HYUNDAI
Technical Service Bulletin

GROUP RECALL	NUMBER 25-01-073H
DATE OCTOBER 2025	MODEL(S) SANTA FE (MX5A)

SUBJECT: STARTER BATTERY TERMINAL BOOT INSPECTION/ADJUSTMENT
 (RECALL 285)

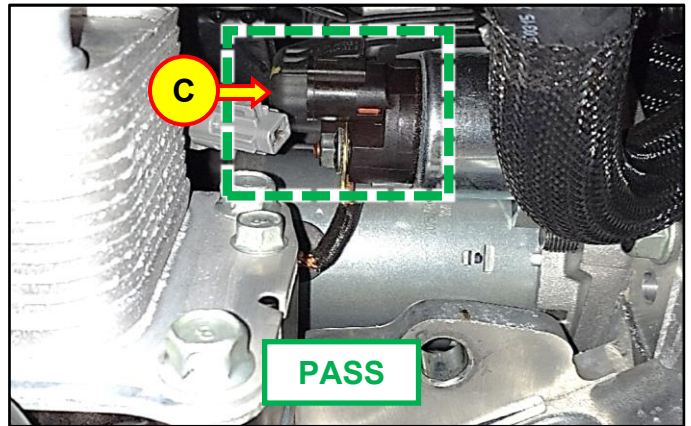
4. Inspect the starter battery terminal boot (C) for proper placement on the battery terminal.

- **PASS:** Boot is covering terminal.

Proceed to the next step.

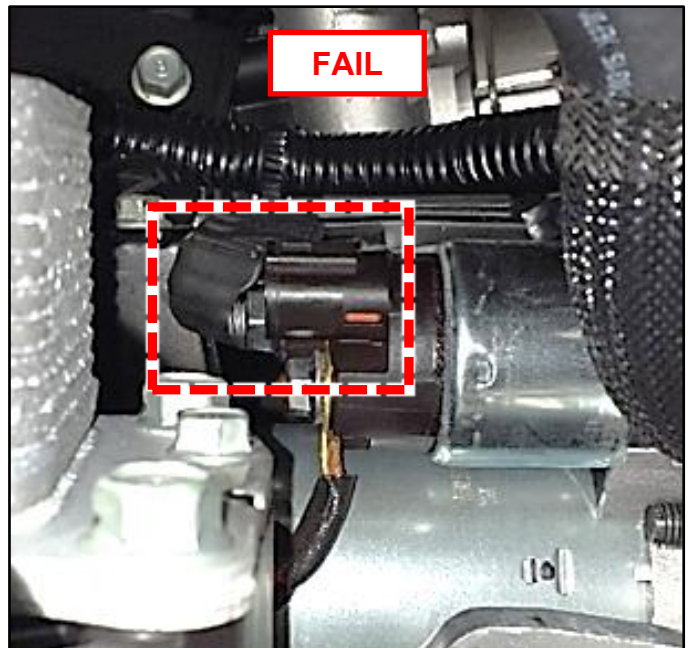
- **FAIL:** Boot is **NOT** covering terminal.

Reposition the boot onto the starter terminal to ensure proper placement. Confirm that the terminal is covered.
